城規會編號：TPB/A/YL-SK/435

提議雨水渠務報告 (Proposed)

事項：回覆 2026 年 4 月 14 日信函的部門意見

A/YL-SK/435 and A/YL-SK/421 簡介

Drawing number : **b2-5**

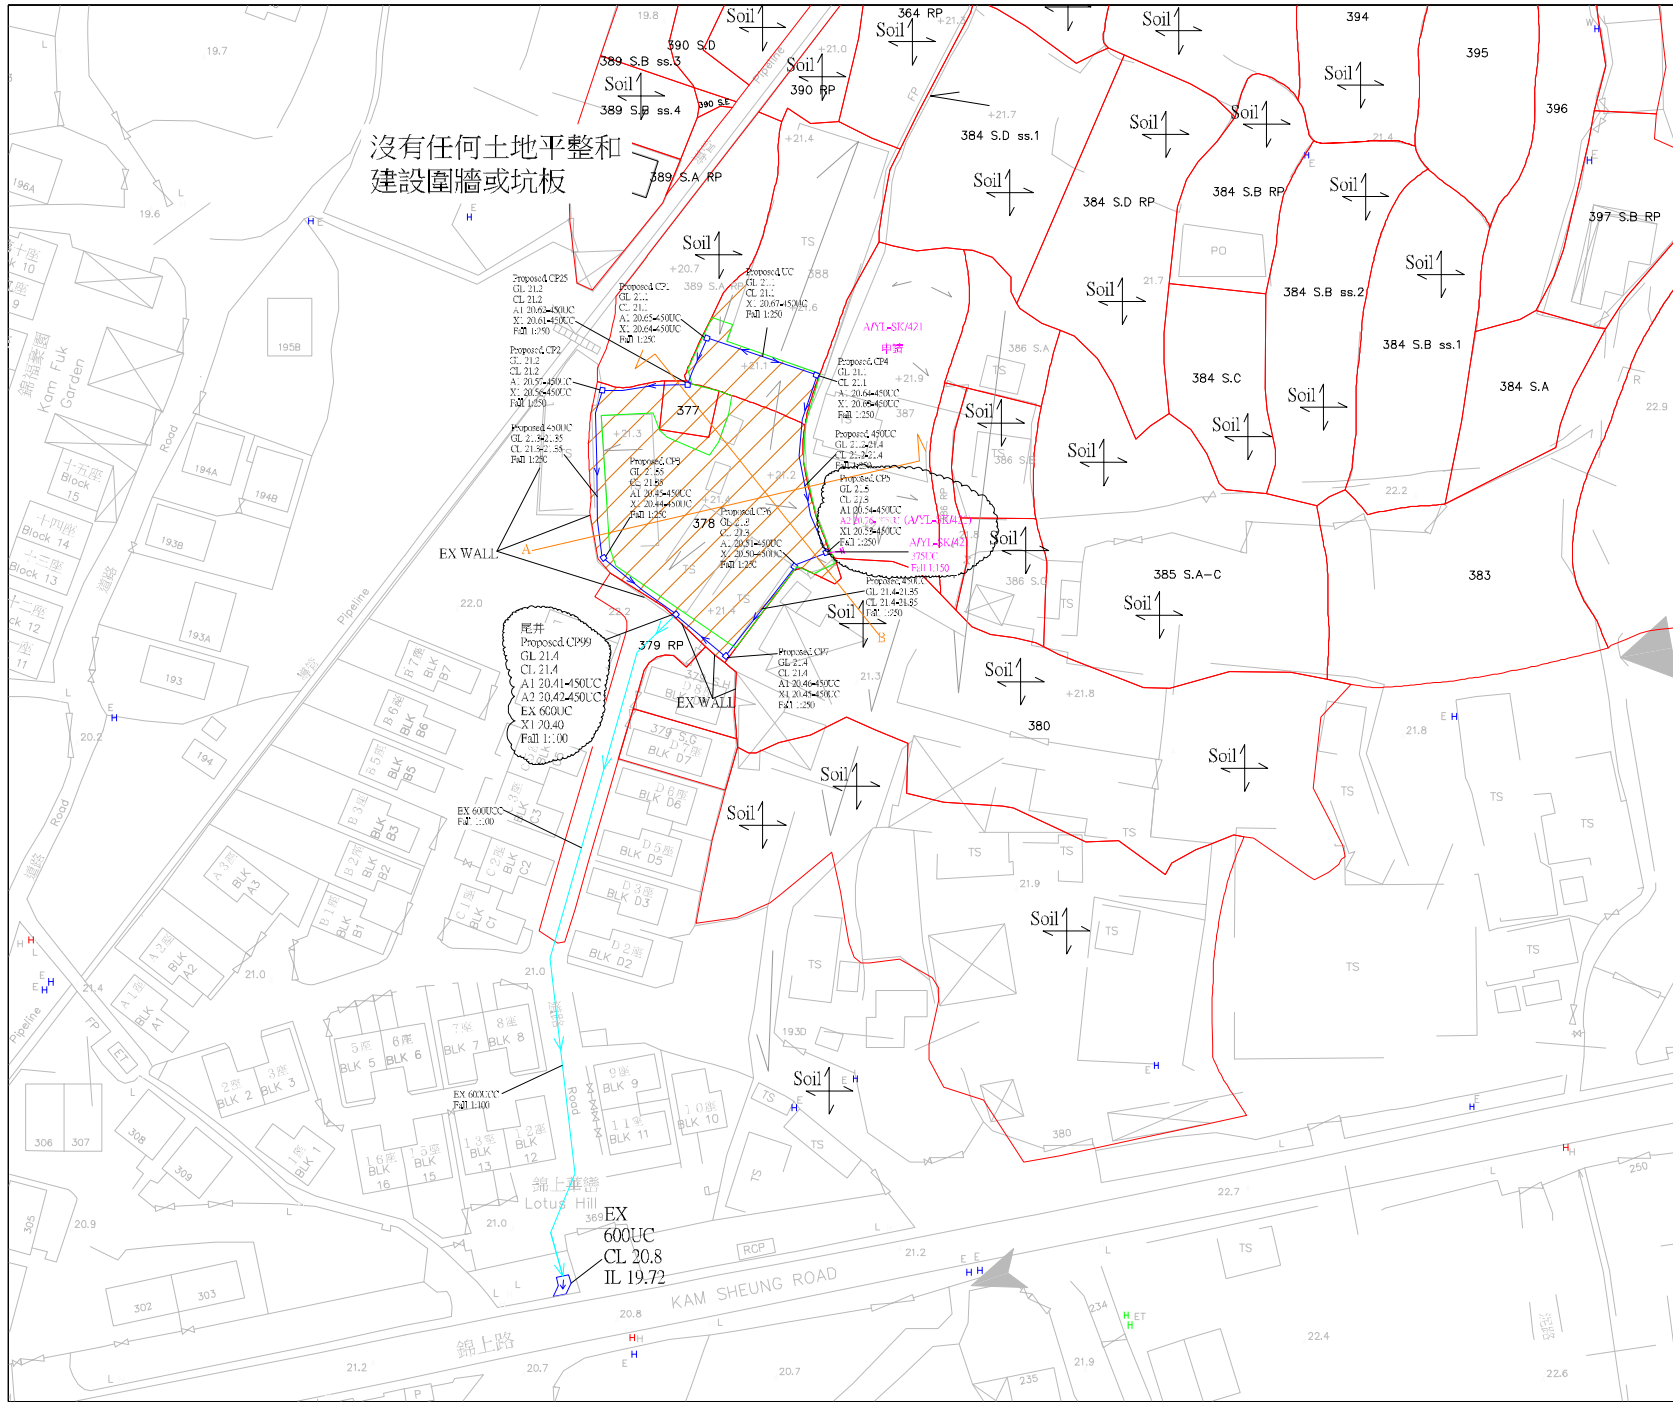
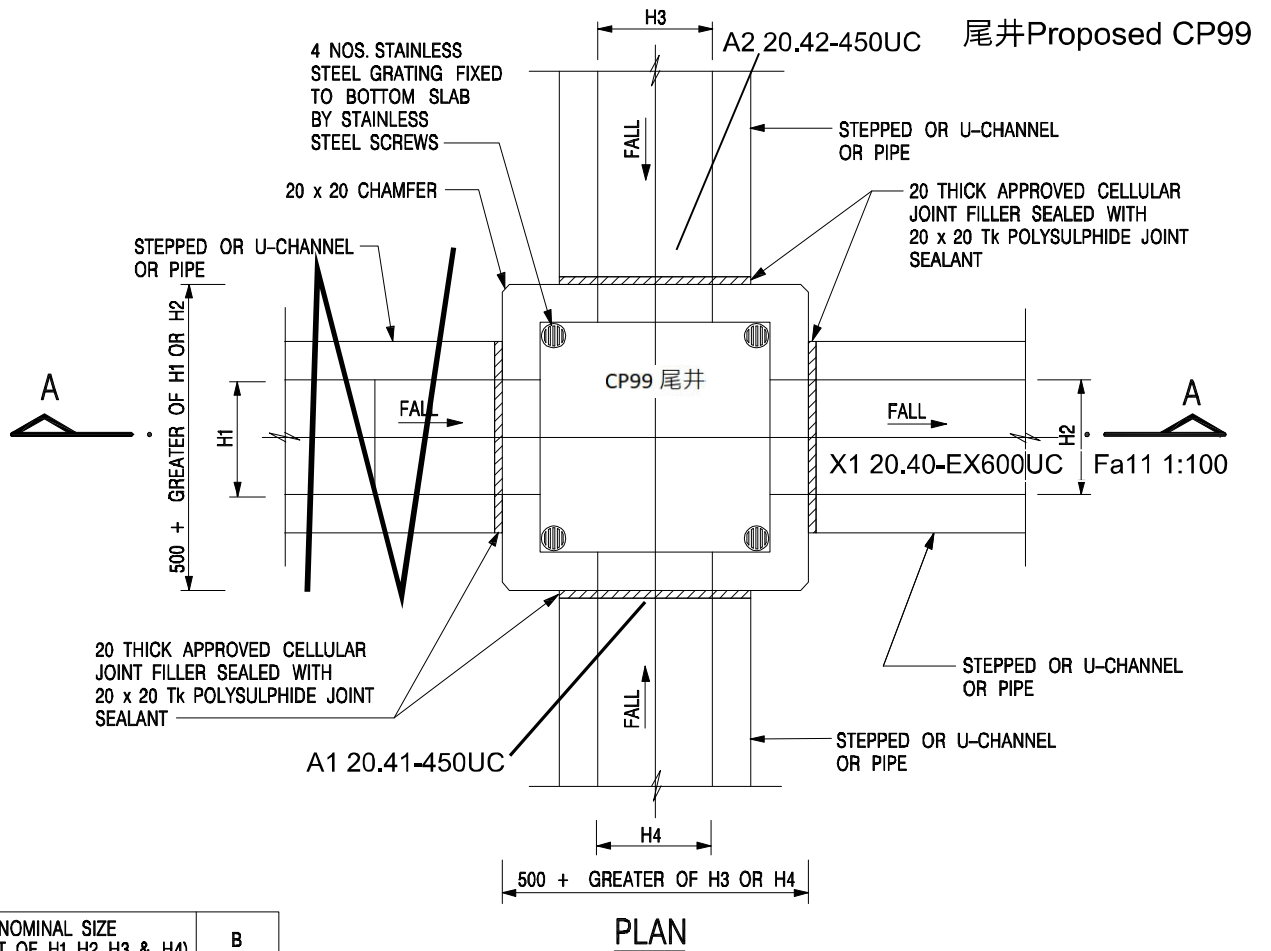
2026-04-15 Comments	回復
i. Since the proposed drainage system from CP5 to CP99 will collect both the surface runoff from the sites (A/YL-SK/435 and A/YL-SK/421) and the overland flow from adjacent lands. Please further review and upgrade the size and/or the gradient of all drainage facilities accordingly.	在b2-5, e1-5, e2-5, e3-5中示
ii. Besides the discharge point for the existing 600mm u-channel at Kam Sheung Road, the applicant should provide more site photos at different locations and views between the proposed last catchpit (CP99) to the existing discharge point at Kam Sheung Road) for review. In addition, please also indicate the alignment of the discharge path for the existing 600mm u-channel at the upstream of CP99 (any part falls within the application site, etc.) and advise if any section of the existing 600mm u-channel is/to be affected due to the proposed development.	由於現場有重型雜物, 復蓋着, 所以暫時拍不了照片, 在批准後做渠務工程和(入HPB1)完成報告時(As-built Record), 才補回相片.

iii. Sand trap or provision alike should be provided before the collected runoff is discharged to the public drainage facilities. Please clearly indicate the above for the proposed last catchpit (CP99) on the drainage plan (Drawing No. b2-3) for clarity.	在b2-5, b7-5 中示
iv. The existing 600mm u-channel, to which the applicant proposed to discharge the stormwater from the subject site was not maintained by this office. The applicant(s) shall resolve any conflict/disagreement arisen for discharging the runoff from the application site(s) to the proposed discharge point(s). In the case that it is a local village drains, DO/YL should be consulted. Moreover, the applicant(s) should ensure that this drainage system and the existing downstream drains/channels/streams have adequate capacity to convey the additional runoff from the application site(s). Regular maintenance should be carried out by the applicant(s) to avoid blockage of the system.	知道和明白
